RotorSport UK Ltd Service Bulletin (Permit)

Title: MTOsport 2017 radio antenna position improvement		Release date 10.10.2020
SB-139 Iss1	Related documents Modification: CCAR No.: None	Compliance Category: OPTIONAL or RECOMMENDED or MANDATORY
	Applicability	
Aircraft type & model: MTOsport 2017	Aircraft serial Nos. affected: As required, optional	
The maintenance manual to be referenced is this stated or subsequent issue.		None
<p>This form is the response from RotorSport UK Ltd either against a problem found in the product in service requiring a containment or rectification action, or as service information for aircraft modification incorporation. For help, contact RotorSport on 44(0)1588 505060, or email compliance@rotorsport.org.</p> <p>The technical content of this document is approved under the authority of the UK CAA Design Organisation Approval Ref: DAI/9917/06</p>

Title: MTO2017 Radio Antenna Repositioning		
AG-SB-2020-07-B-EN		Compliance Category: A – MANDATORY B – RECOMMENDED C – OPTIONAL
Applicability		
Aircraft type & model: AutoGyro MTO2017	Affected Serial number(s): All MTO2017 variants	
The maintenance manual to be referenced is this stated or subsequent issue.		As

(Pic. 3)

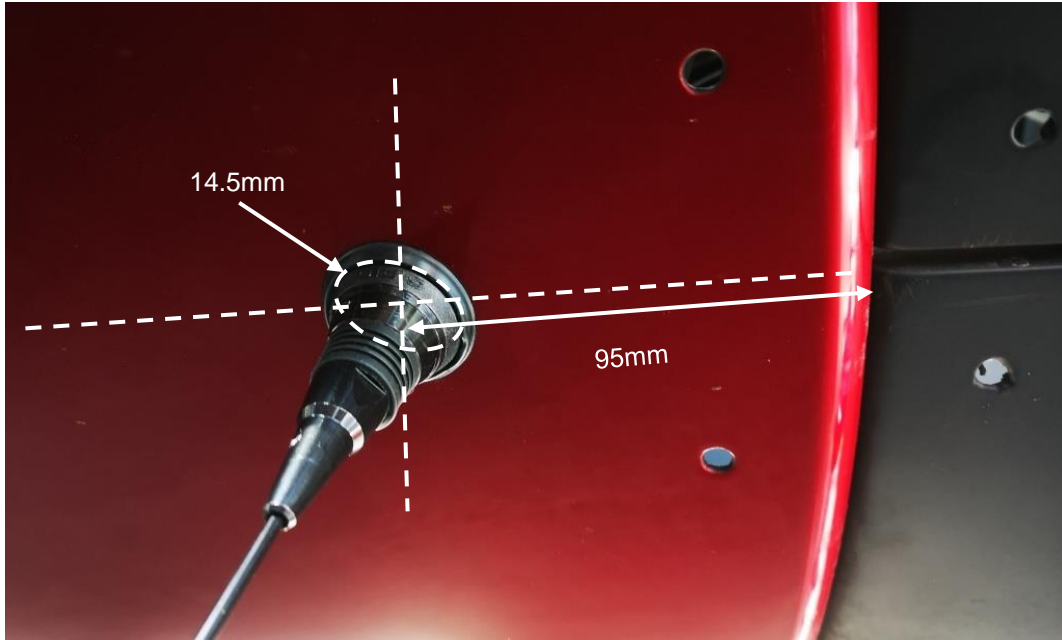
5. Remove the 3 left screws securing the left side rear cockpit cover to the cockpit panel to gain access to the antenna cable behind the cockpit (Pic. 3).
